PRODUCT/PROCESS CHANGE NOTICE (PCN)

PCN #: A1403-01 DATE 3-Apr-2014		MEANS OF DISTINGUISHING CHANGED DEVICES: ☐ Product Mark ☒ Back Mark Lot# will have a "A" prefix to denote alternate site, OSE Taiwan. ☐ Date Code ☐ Other
Product Affected: SOIC-28 Refer to Attachment II for the affected part numbers		
Date Effective: 3-Jul-2014		
Contact: IDT PCN DESK	Attachment: ☒ Yes ☐ No	
E-mail: pcndesk@idt.com	Samples: Please contact your local sales representative for sample request & availability.

PCN Type: Manufacturing Site - Alternate Assembly Location

Table 2: Comparizon of Package Outline Dimensions on the Existing Assembly and Alternate Assembly

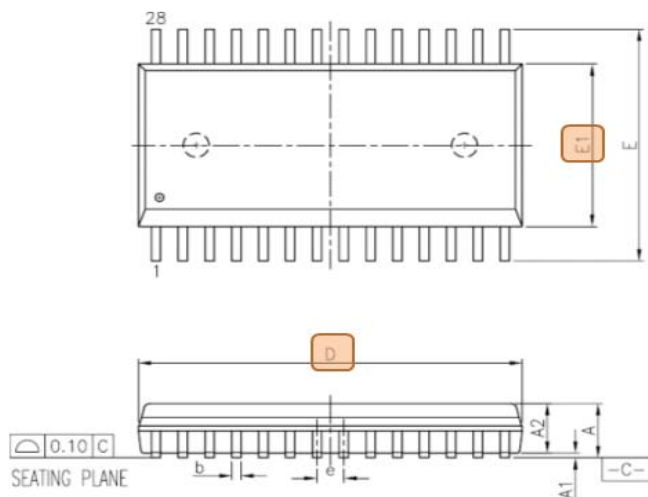
There are minor changes on the package dimensions as shown in Table 2.

POD SYMBOL	Unisem mils	OSE mils	Jedec mils	Remarks
D (body length)	718~728	697~733	697~733	No impact to design board footprint
E1 (body width)	340~350	324~350	324~350
